Access Compliance Report

Public Rights-of-Way

(Curb Ramps)

Intersection ID: 27254	Main Street: PIPER_STATION_DR	Cross Street: SPINDLETOP_PL	Location: SE
ADA ID: 0992C257E501	Ramp Type: Perp	Initial Pass/Fail: Fail	Overall Compliance: No
Severity Score: 33.75			
Codes/Mitigation Info/Possible Solution		Field Measurements/Component Compliance

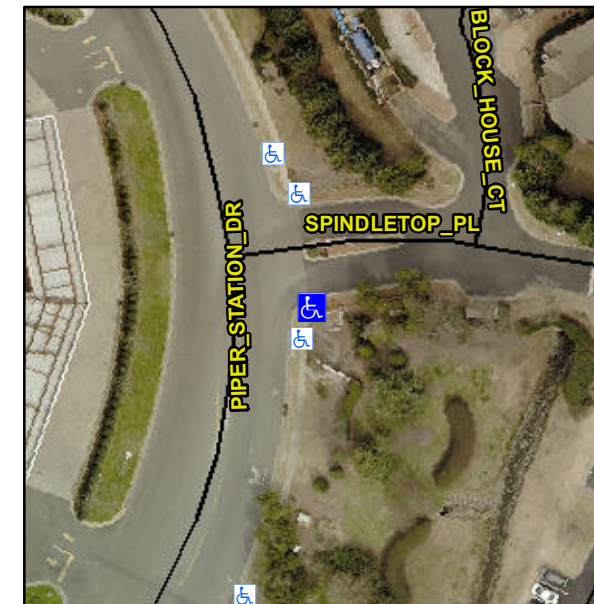
R304.5.1, R304.2.2, R304.5.3

Compliance	Description	Data	Compliance	Description	Data
N/A	Ramp Length (in)	50.0	No	Ramp Slope (%)	8.5
No	Ramp Width (in)	46.5	No	Ramp XSlope (%)	6.4
N/A	Flare Type LT	N/A	N/A	Flare Type RT	N/A
N/A	Flare Slope LT (%)	N/A	N/A	Flare Slope RT (%)	N/A
N/A	Flare Traversable LT?	N/A	N/A	Flare Traversable RT?	N/A
N/A	Landing Length (in)	N/A	N/A	DWS Provided?	N/A
N/A	Landing Width (in)	N/A	N/A	DWS Contrast?	N/A
N/A	Landing Slope (%)	N/A	N/A	DWS Length (in)	N/A
N/A	Landing X Slope (%)	N/A	N/A	DWS Full Width?	N/A
N/A	Landing Curb? (Y/N)	N/A	N/A	DWS Offset (in)	N/A
N/A	Shared Landing?	N/A			
N/A	Gutter Ponding?	N/A	N/A	Gutter Slope (%)	N/A
N/A	Gutter Lip Ht (in)	N/A	N/A	Gutter X Slope (%)	N/A
N/A	Painted X Walk1?	No	N/A	Painted X Walk2?	N/A
	X Walk 1 Direction	To N		X Walk 2 Direction	N/A
N/A	X Walk 1 Width (in)	N/A	N/A	X Walk 2 Width (in)	N/A
	X Walk 1 Slope (%)	2.5		X Walk 2 Slope (%)	N/A
	X Walk 1 X Slope (%)	3.6		X Walk 2 X Slope (%)	N/A

Remove & Replace Entire Ramp.
